Our Ref: 3402-01/LK

**PROPOSED MANUFACTURING FACILITY AND ASSOCIATED CAR PARKING AND
LANDSCAPING, IPSEN BIOPHARM, WREXHAM INDUSTRIAL ESTATE
PLANNING APPLICATION REFERENCE P/2023/0482**

From:	Chief Officer, Environment & Technical	To:	Chief Officer Planning & Regulatory
Our Ref:	ET/DC/MM/P/2023/0482	FAO:	Jenni Perkins
		Your Ref:	P/2023/0482
Date:	21 September 2023

Land at Ash Road North, Wrexham Industrial Estate, LL13 9JT Construction of manufacturing facility and associated car parking and landscaping

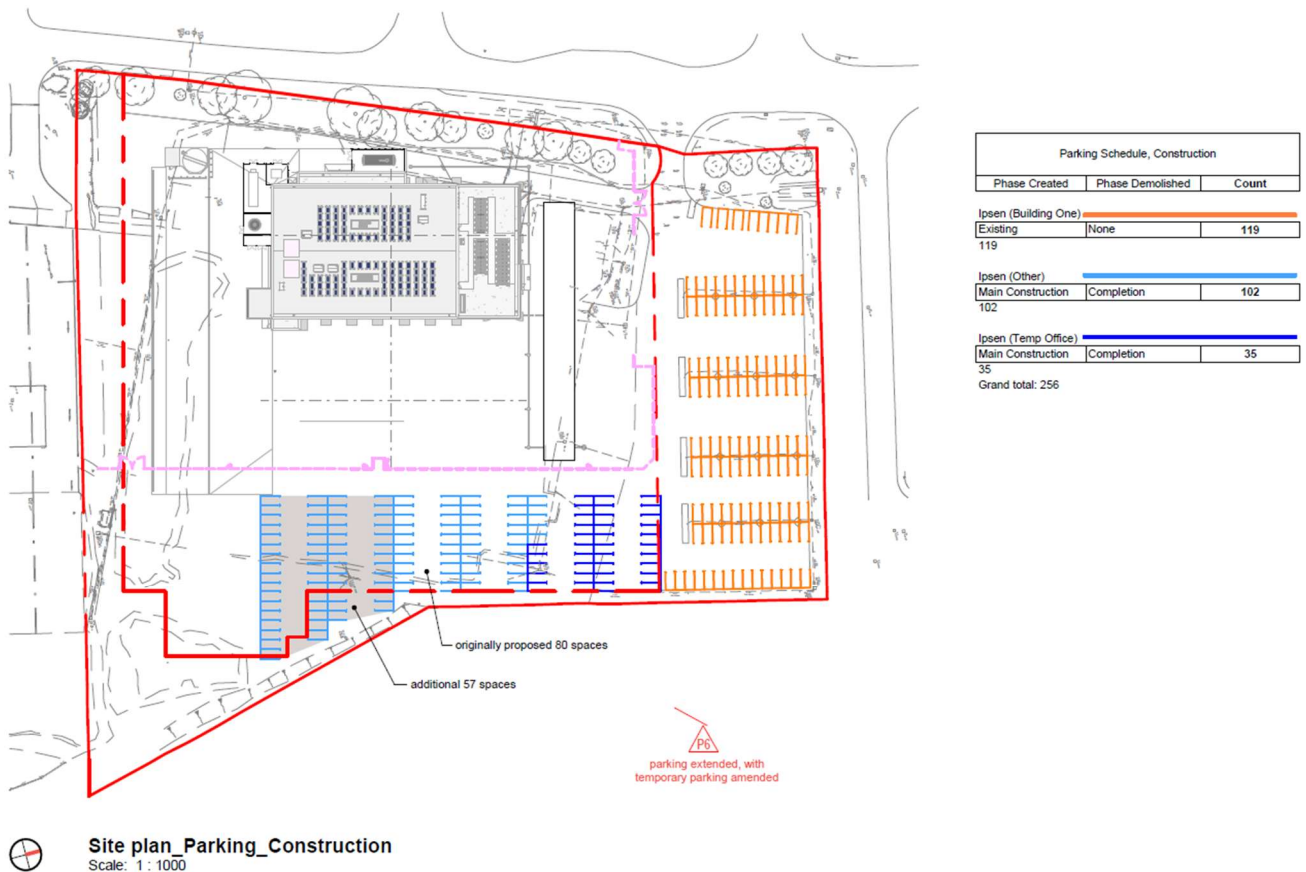
Comments: *“A parking phasing plan showing parking arrangements during the construction period and how parking will be phased with the temporary office building.”*

The parking phasing drawing indicates the current and final parking layout. WCBC request a phasing plan to show parking arrangements during the construction period. This should also include parking phasing associated with the temporary office building to ensure there is no shortfall in provision.

The sketch below shows how the temporary parking layout would work during the construction. A total of 256 spaces would be retained at all times, in advance of the Proposed NDP Building being completed, at which stage the parking layout on the drawing enclosed with this letter would be available for use.

During construction, all contractor parking demand and laydown areas will be provided for within the pink dashed hoarding line shown on the sketch below, therefore contractors will not need any of the surrounding 256 spaces, which would remain open for Ipsen staff to utilise.

3402-01-ATR01

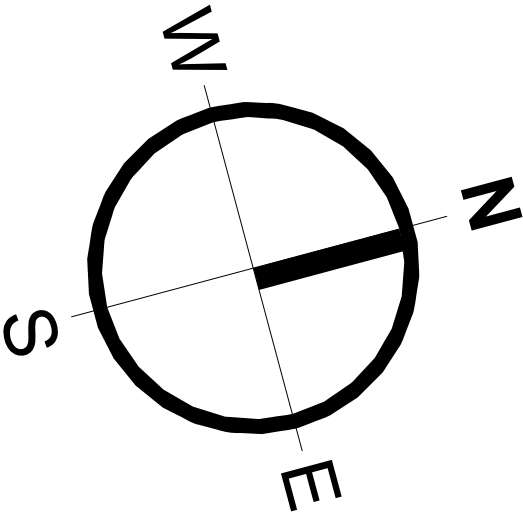
Comments: ***"A revised site access arrangement to accommodate two-way vehicle movements. Tracking should be provided to evidence two-way movements can be achieved."***

Comments: *“A visibility splay for the site access junction in accordance with TAN18.”*

It is proposed the existing access will be retained for the development. Swept path drawings have been provided for a 16.5m rigid HGV and 15T tanker, the largest vehicles which will access the site. The access is approximately 6.5m wide at its narrowest point. As such the tracking indicates there is insufficient width to allow a car to pass while a HGV is entering/exiting the site. WCBC request the access is widened to permit two-way vehicle movements with revised tracking demonstrating this arrangement.

WCBC request a visibility splay is provided for the existing site access junction in accordance with TAN18.

Nonetheless, to address the LHA's comments, a minor scheme of widening is now proposed at the site access, as shown on the revised **drawing number 3402-01-ATR01 Rev A**, enclosed with this letter. The widening can be achieved internally within the site red-line boundary and private land ownership of the Applicant, without affecting the adopted highway.

With the proposed minor scheme of widening in place, the drawing demonstrates that a car would be able to satisfactorily pass an articulated bulk tanker vehicle at the site access.

Drawing number 3402-01-ATR01 Rev A, enclosed with this letter, demonstrates that 2.4m x 120m junction visibility splays are achievable from the site access, which is commensurate with the highway standards contained in TAN18 for a 40mph road (as per the speed limit on Ash Road North).

LMA Project		Drawing number						Rev.	
Project	Originator	Zone	Level	Type	Rev	DrawingNumber			
2227	IED	LMA	XX	XX	DR	A	9516	P6

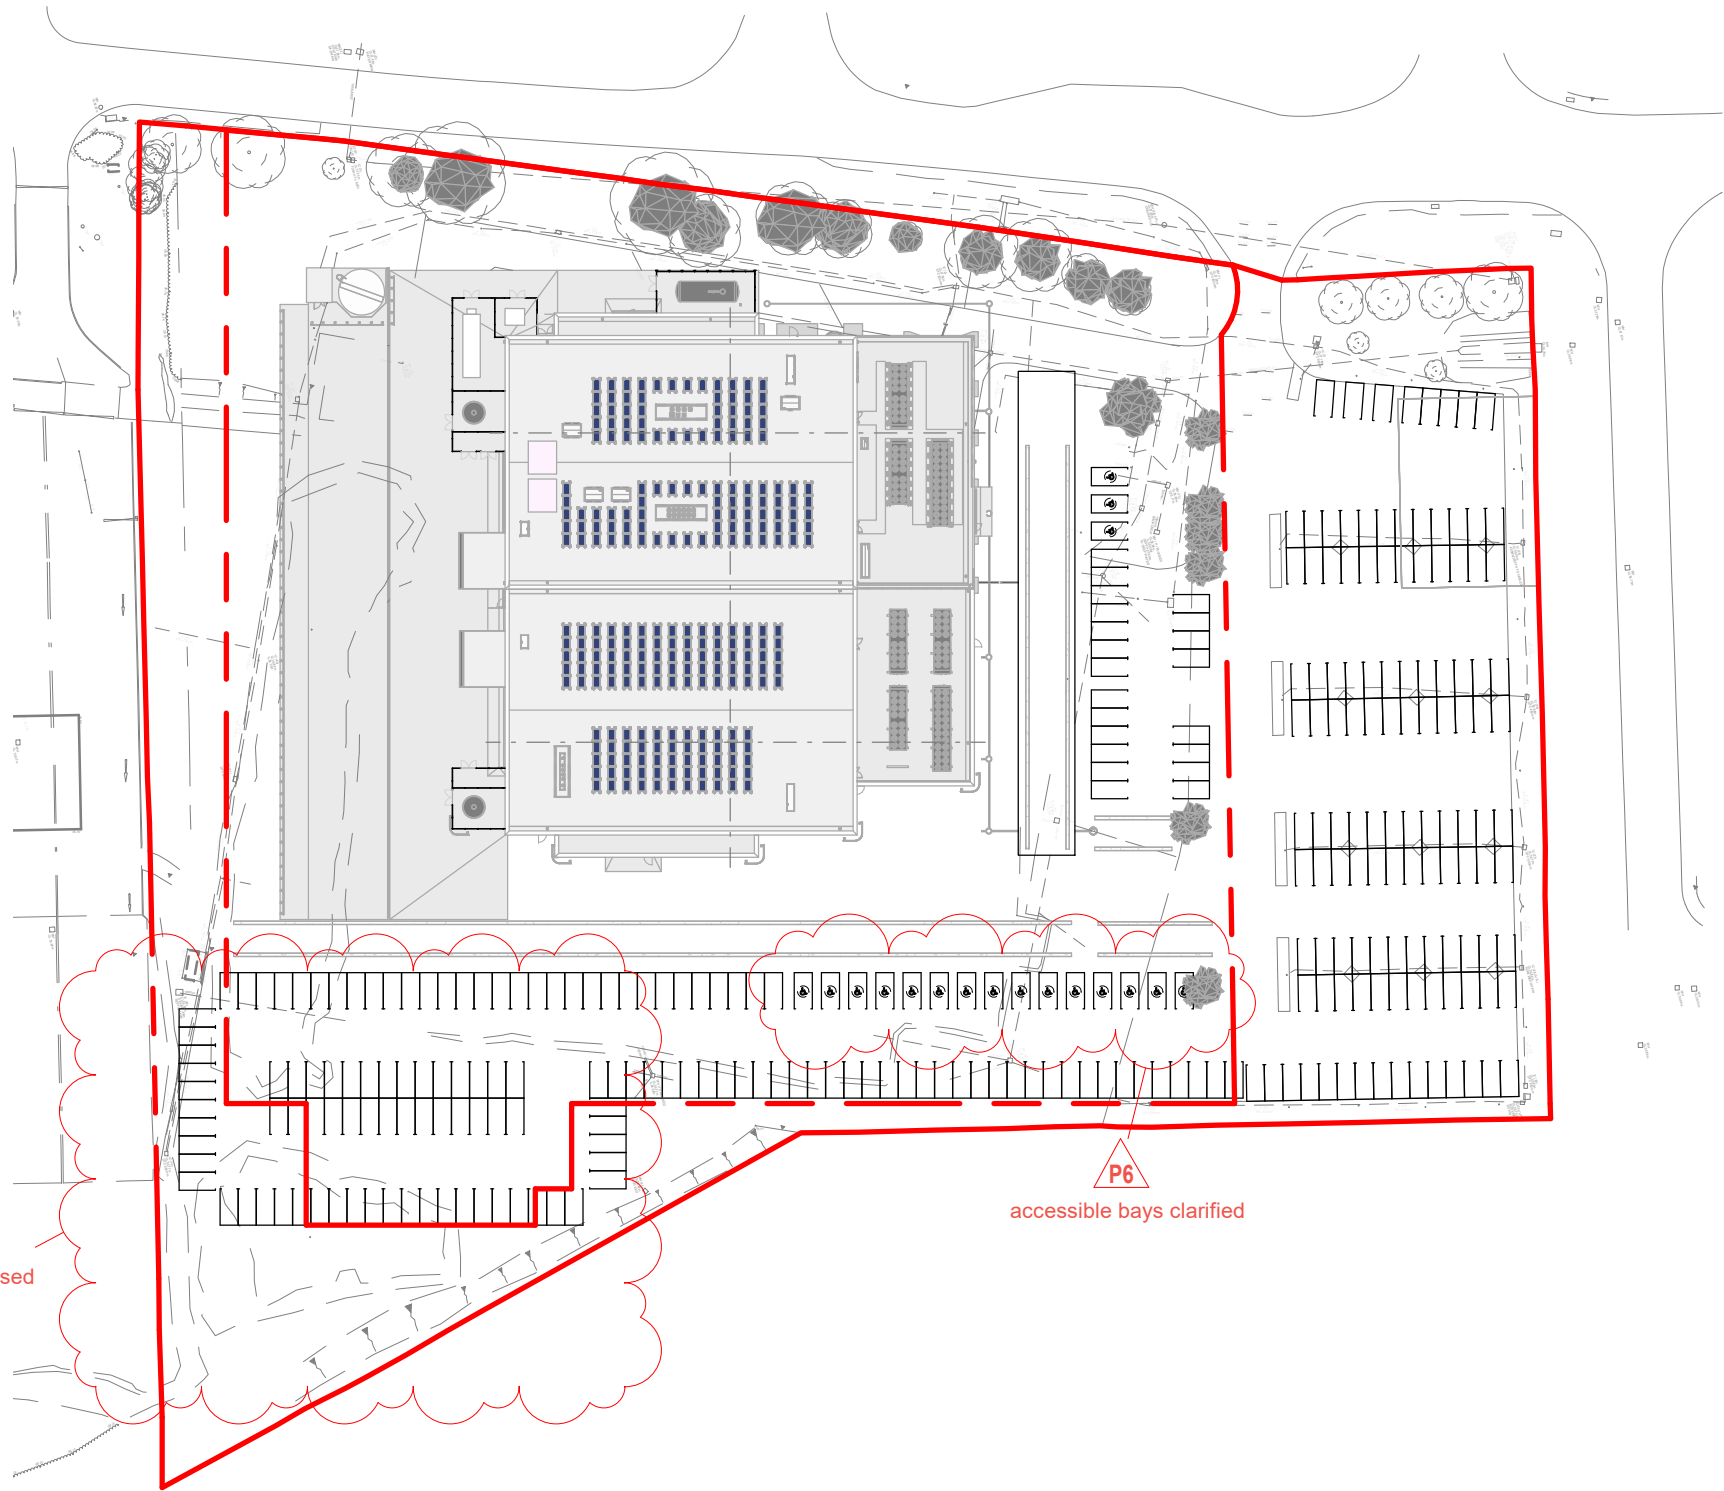
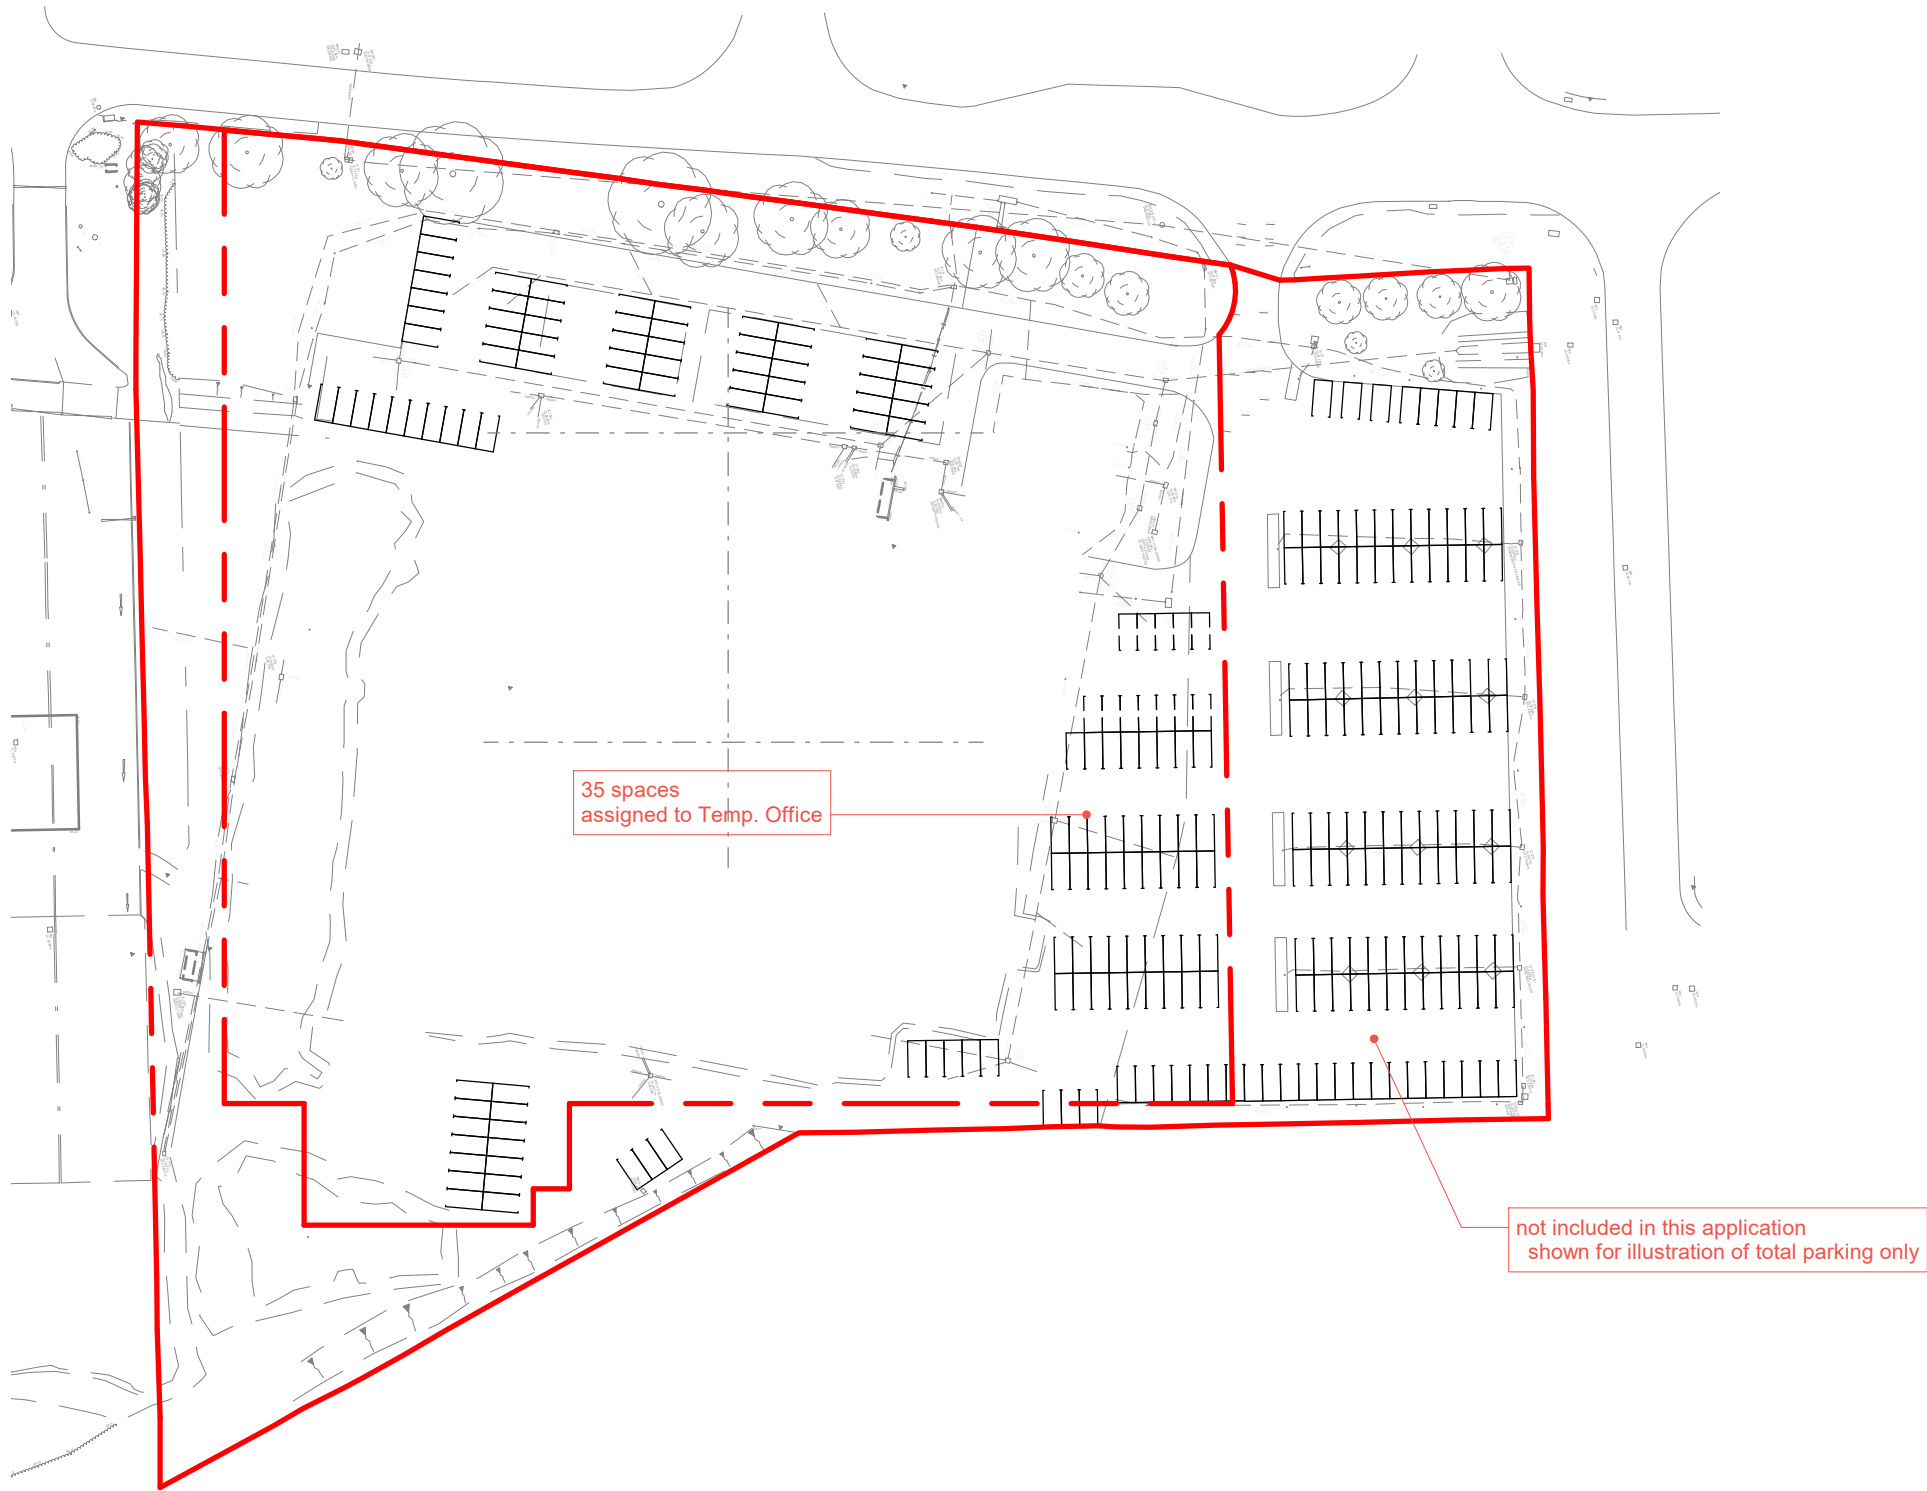
Comments: *“Evidence the existing number of car parking spaces will be sufficient to meet future demand and how the 24 lost spaces will be accommodated.”*

Comments: *“Clarification on the number and location of accessible car parking spaces.”*

Based on LPG16 10% of all spaces should be accessible spaces. WCBC request clarification from the applicant on the number and location of accessible parking spaces within the total 145 space car park within the application boundary.

A total of 24 out of the 145 car parking spaces would be allocated for staff at the proposed building. This is well below the maximum potentially permitted under LPG16 for either B2 or B8 use. The remaining spaces would continue to be used by Ipsen staff working in the facility on the western side of Ash Road North. The applicant is requested to confirm how the 24 lost spaces will be accommodated.

In order to address this issue in an expedient manner, the proposed site layout plan has been revised to include an additional 24 overflow parking spaces (making 288 in overall total), which have been added in the south-eastern corner of the overall site. This is shown on the revised site layout plan (**drawing number 2227 IED LMA XX XX DR A 9516 Rev P6**, enclosed with this letter).

Technically, the LPG16 requirement for the provision of 10% accessible bays should only apply to those new spaces that are to be added for the Proposed Development (i.e. 10% of 24 = 3 spaces). These are shown on the revised site layout plan (**drawing number 2227 IED LMA XX XX DR A 9516 Rev P6** enclosed with this letter).

Notwithstanding this, the revised site layout plan also demonstrates that, as part of the reorganisation of the existing 145 spaces within the red-line boundary, 15 further accessible standard bays will also be added, to effectively retrospectively improve provision for those existing Ipsen staff members who need it.
